## ADDENDUM NO. 1

**TO: PLANS AND SPECIFICATIONS FOR STATE OF MISSOURI**

**Upgrade Electric Network  
Camp Rising Sun  
Lake of the Ozarks State Park  
Kaiser, Missouri  
PROJECT NO.: X2202-01**

SHEET TITLE:  
**ELECTRICAL SITE  
DEMOLITION PLAN  
- NORTH**

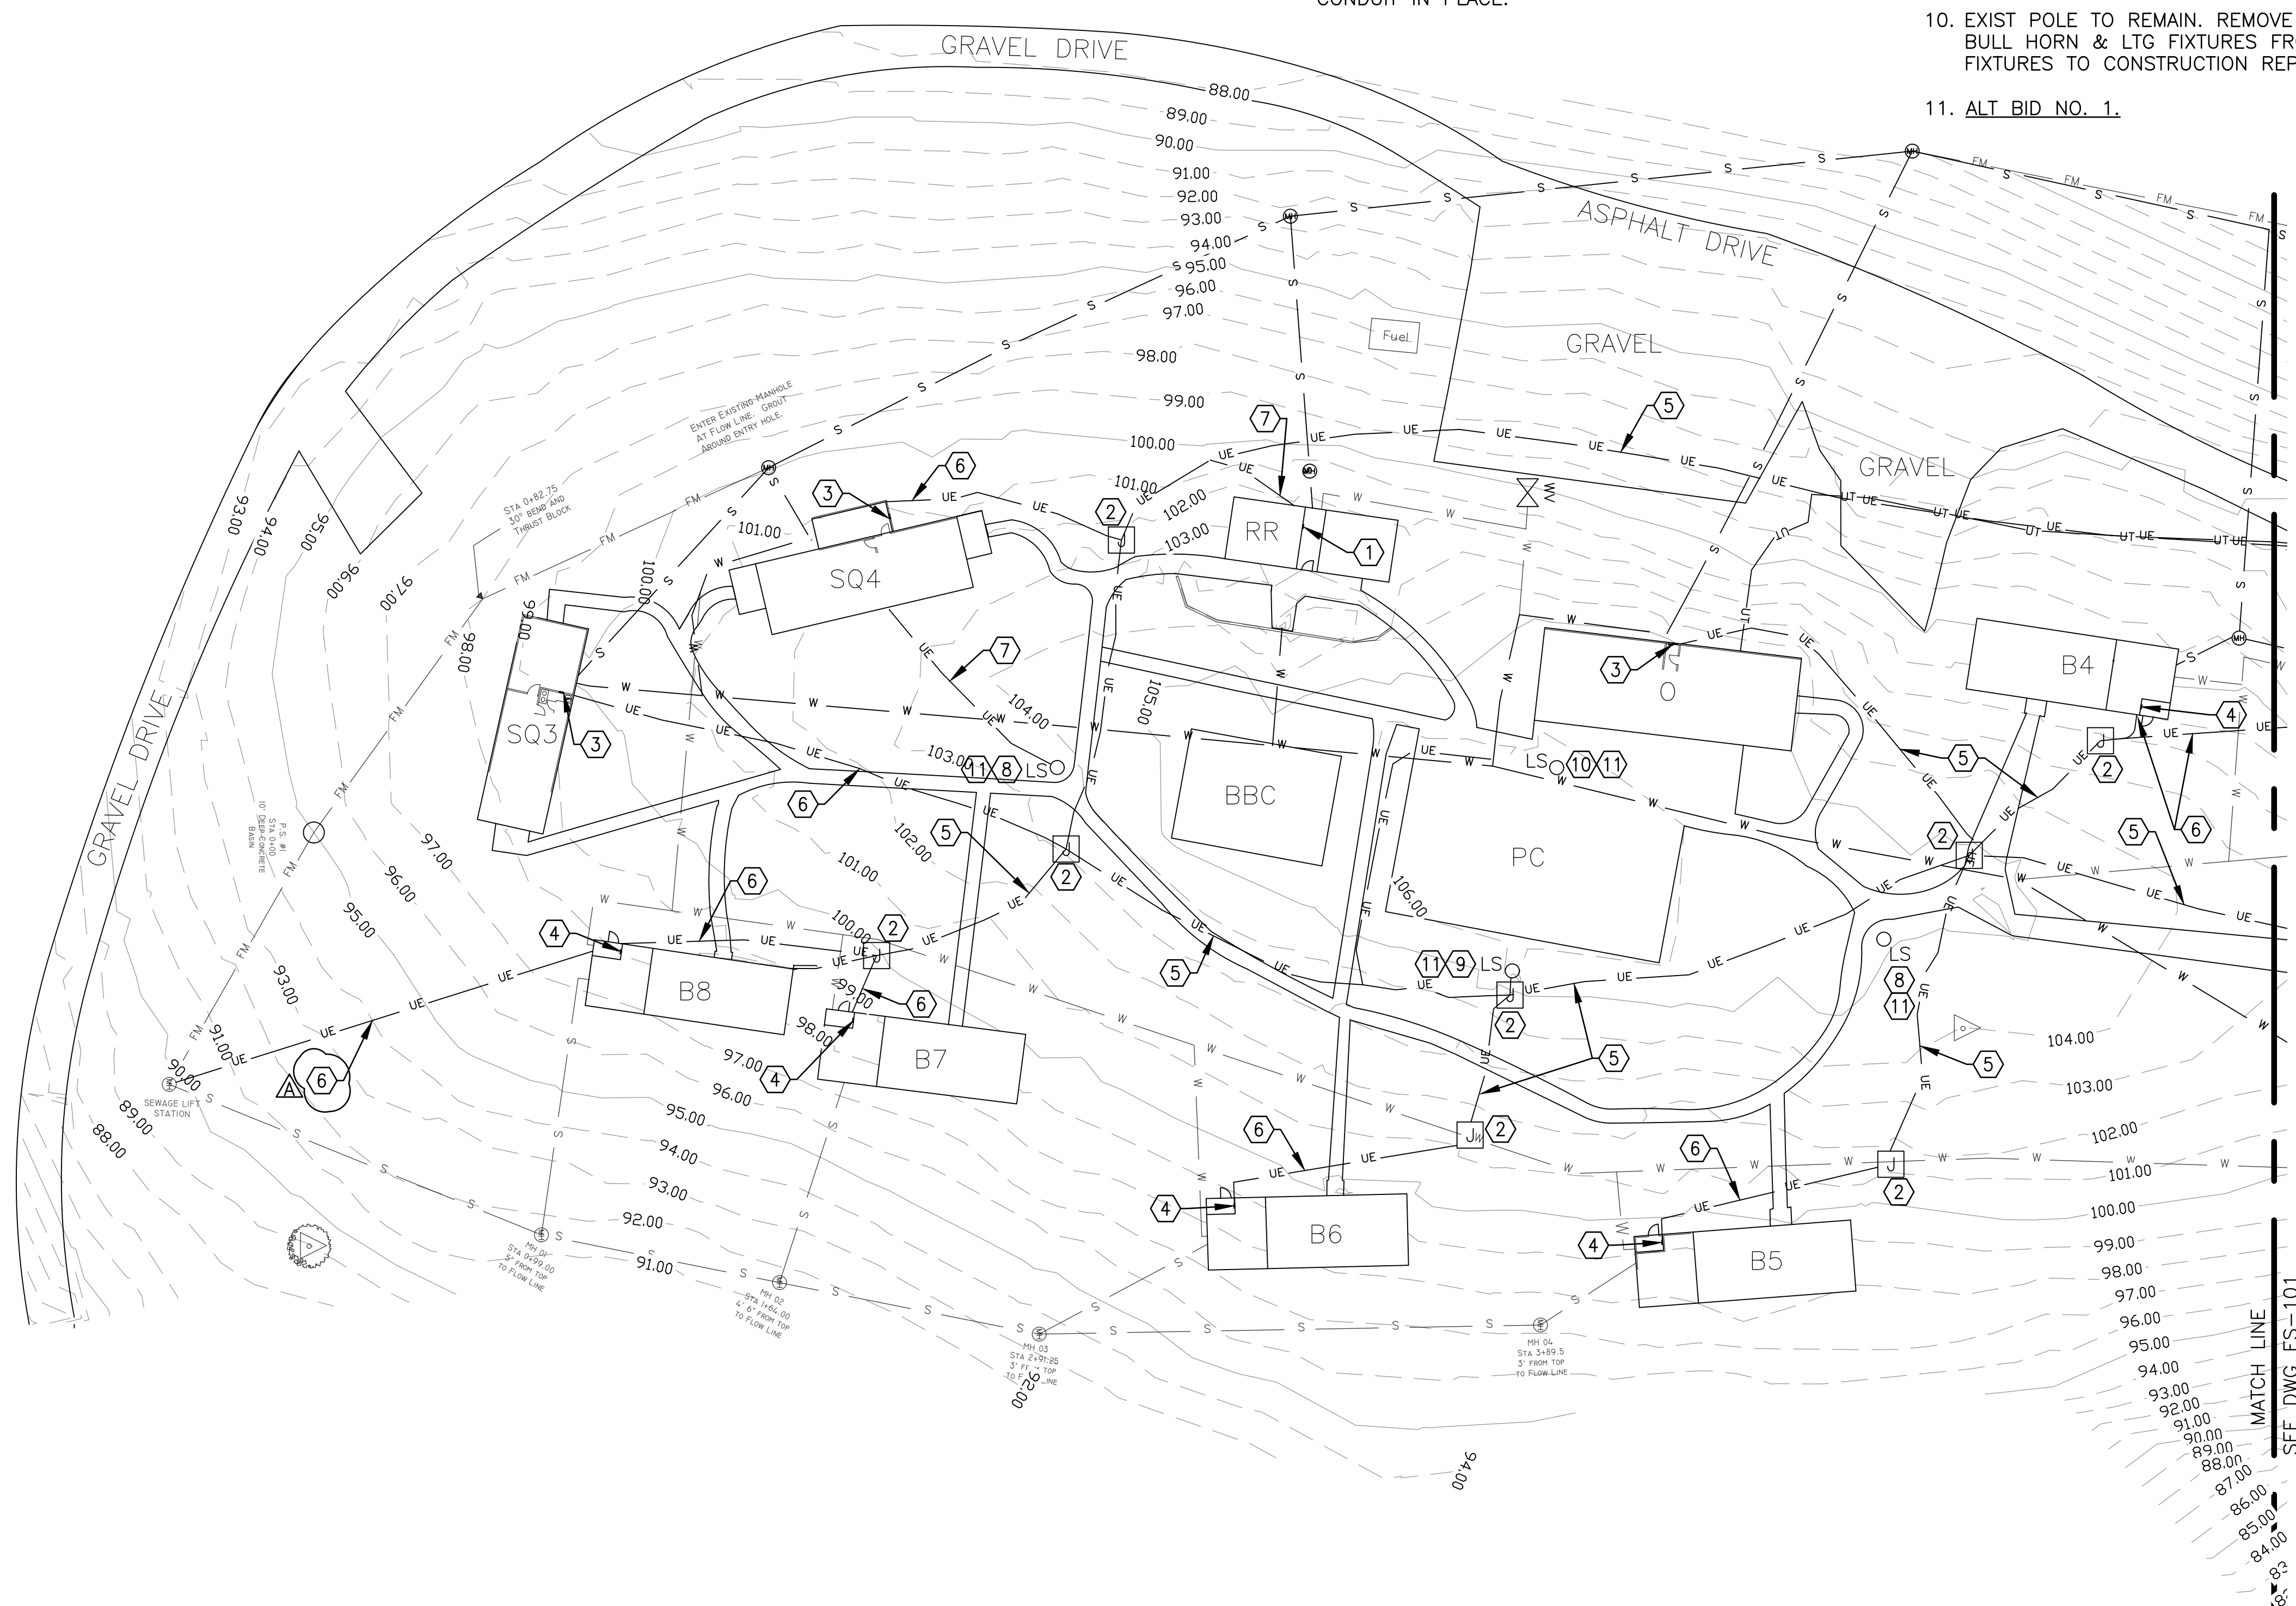
1. Sheet E-001 – Electrical Symbols, Abbreviations & General Notes
  - a. REVISE per attached Revision A, dated 05/11/2023.
2. Sheet ES-101 – Electrical Site Demolition Plan - North
  - a. REVISE per attached Revision A, dated 05/11/2023.
3. Sheet ES-102 – Electrical Site Demolition Plan - South
  - a. REVISE per attached Revision A, dated 05/11/2023.
4. Sheet ES-103 – Electrical Site Plan - North
  - a. REVISE per attached Revision A, dated 05/11/2023.
5. Sheet ES-104 – Electrical Site Plan - South
  - a. REVISE per attached Revision A, dated 05/11/2023.
6. Sheet ED-601 – One-Line Diagram - Demolition
  - a. REVISE per attached Revision A, dated 05/11/2023.
7. Sheet E-401 – Electrical Plans
  - a. REVISE per attached Revision A, dated 05/11/2023.
8. Sheet E-502 – Lighting Fixture Installation Details - Alt Bid No. 1
  - a. REVISE per attached Revision A, dated 05/11/2023.

- ▲ 15. PROVIDE NEW FEEDER FROM J-BOX TO ELECT PNL ON 1ST FLR LEVEL.
- ▲ 16. ALT BID NO. 1.

SHEET TITLE:  
**ONE-LINE  
DIAGRAM**

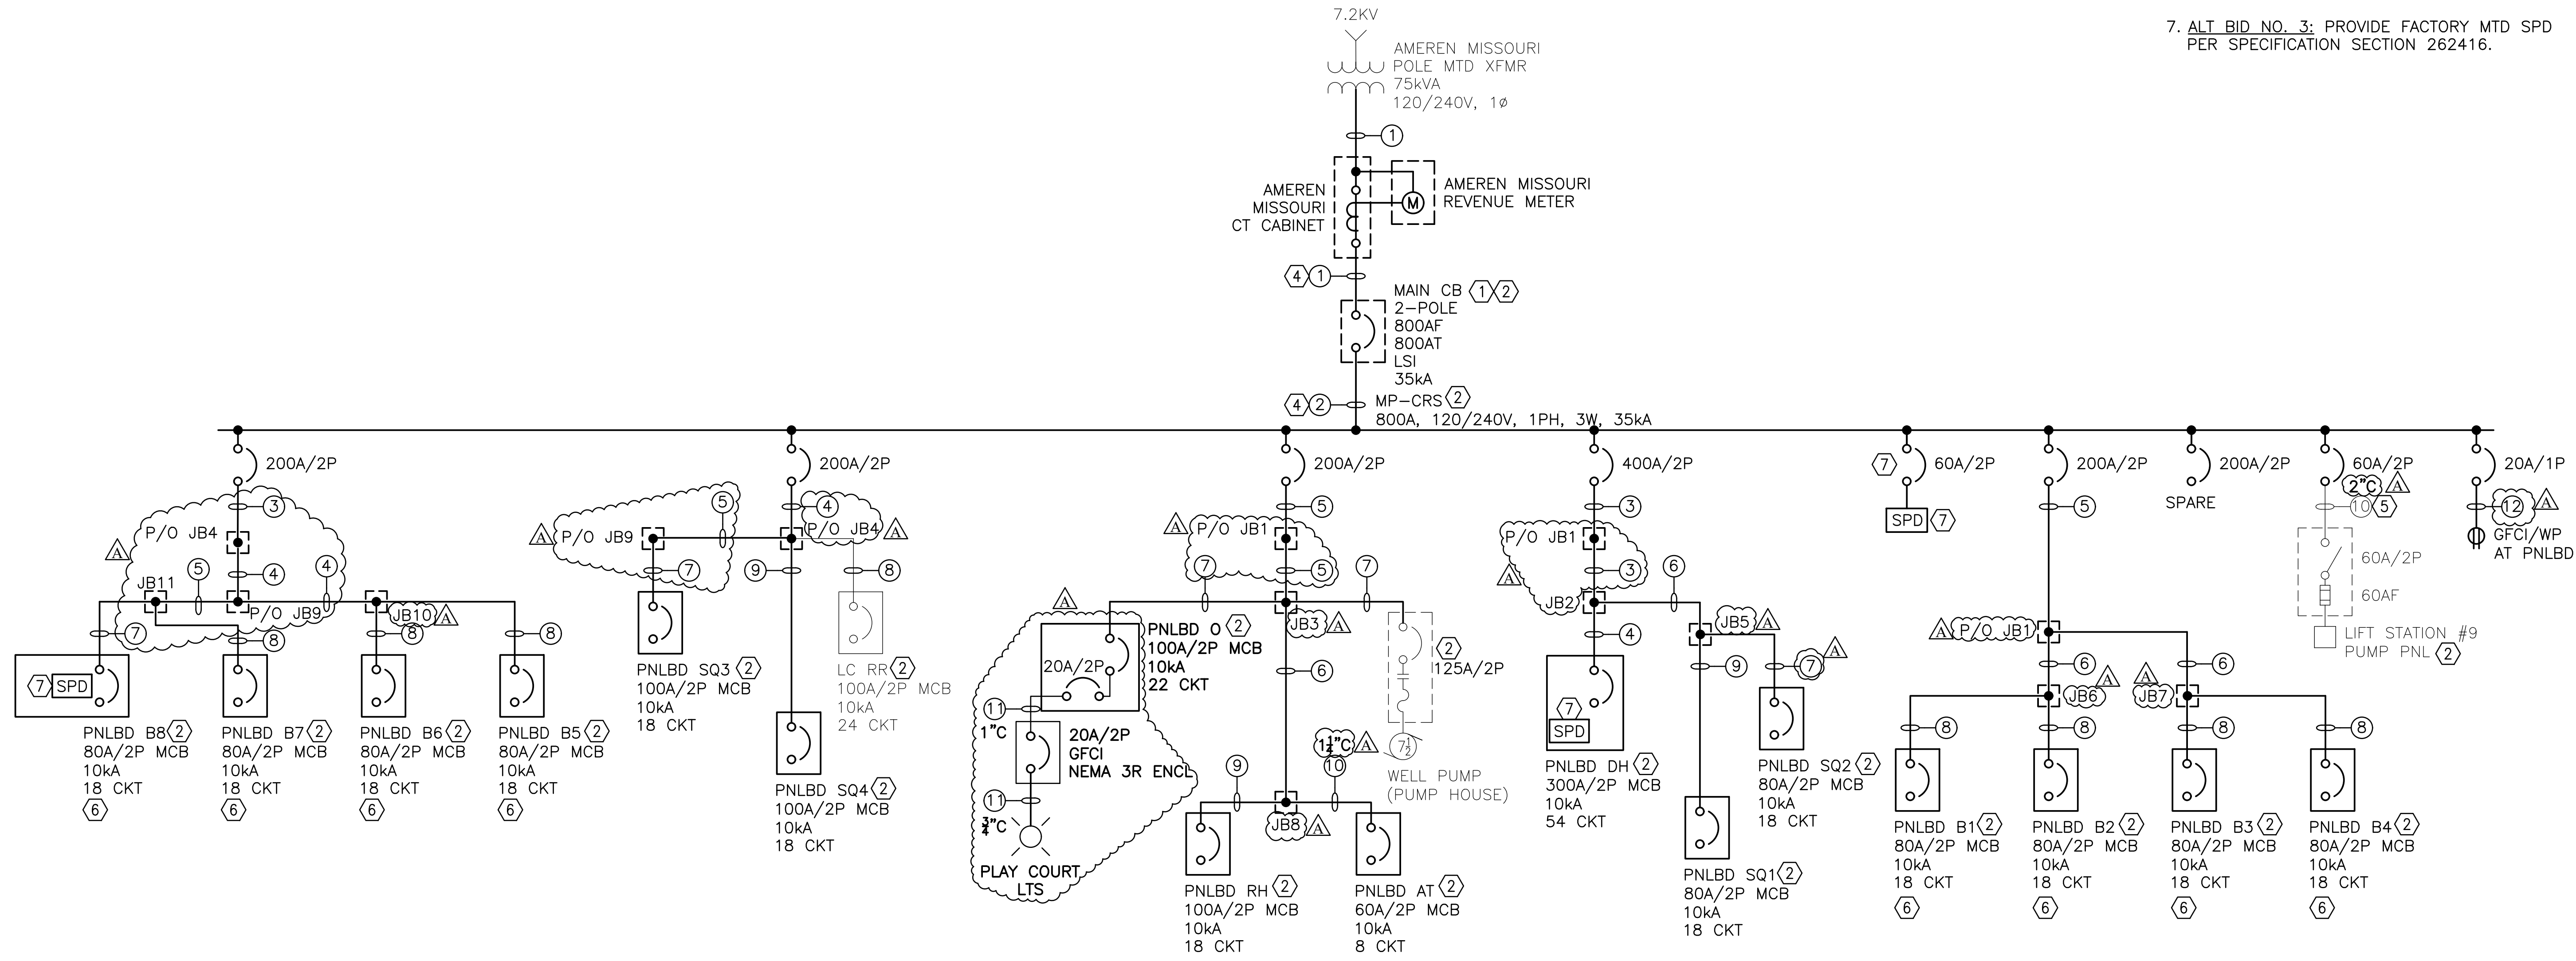
9. Sheet E-601 – One-Line Diagram
  - a. REVISE per attached Revision A, dated 05/11/2023.
10. Sheet E-603 – Panelboard & Lighting Fixture Schedules & Alt Bid No. 1
  - a. REVISE per attached Revision A, dated 05/11/2023.
